Access Compliance Report

Public Rights-of-Way

(Curb Ramps)

Intersection ID: 13767	Main Street: E_5TH_ST	Cross Street: PARK_DR	Location:	N
ADA ID: 5AA94DC451DA	Ramp Type: Perp	Initial Pass/Fail: Fail	Overall Compliance: No	Severity Score: 12.5
Codes/Mitigation Info/Possible Solution		Field Measurements/Component Compliance

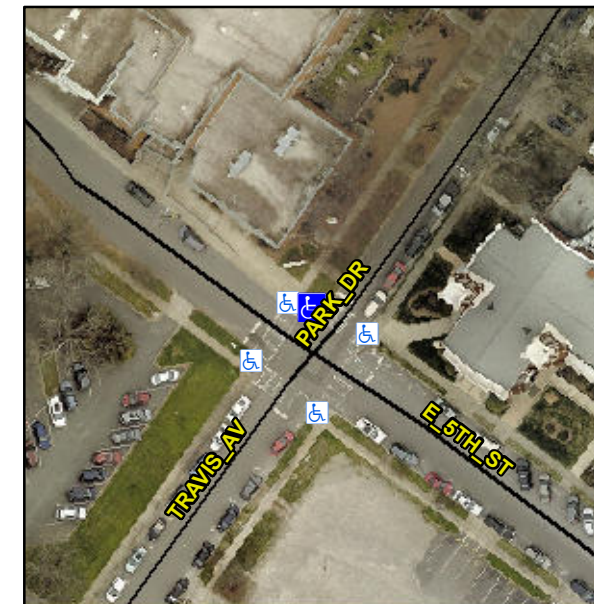
Not Found, R304.2.2

Compliance	Description	Data	Compliance	Description	Data
N/A	Ramp Length (in)	60.0	No	Ramp Slope (%)	10.0
Yes	Ramp Width (in)	120.0	Yes	Ramp XSlope (%)	1.1
N/A	Flare Type LT	N/A	N/A	Flare Type RT	N/A
N/A	Flare Slope LT (%)	N/A	N/A	Flare Slope RT (%)	N/A
N/A	Flare Traversable LT?	N/A	N/A	Flare Traversable RT?	N/A
N/A	Landing Length (in)	N/A	N/A	DWS Provided?	N/A
N/A	Landing Width (in)	N/A	N/A	DWS Contrast?	N/A
N/A	Landing Slope (%)	N/A	N/A	DWS Length (in)	N/A
N/A	Landing X Slope (%)	N/A	N/A	DWS Full Width?	N/A
N/A	Landing Curb? (Y/N)	N/A	N/A	DWS Offset (in)	N/A
N/A	Shared Landing?	N/A			
N/A	Gutter Ponding?	N/A	N/A	Gutter Slope (%)	N/A
N/A	Gutter Lip Ht (in)	1.0	N/A	Gutter X Slope (%)	N/A
N/A	Painted X Walk1?	Yes	N/A	Painted X Walk2?	N/A
	X Walk 1 Direction	To SE		X Walk 2 Direction	N/A
N/A	X Walk 1 Width (in)	114.0	N/A	X Walk 2 Width (in)	N/A
	X Walk 1 Slope (%)	3.2		X Walk 2 Slope (%)	N/A
	X Walk 1 X Slope (%)	1.6		X Walk 2 X Slope (%)	N/A

Remove & Replace Entire Ramp.
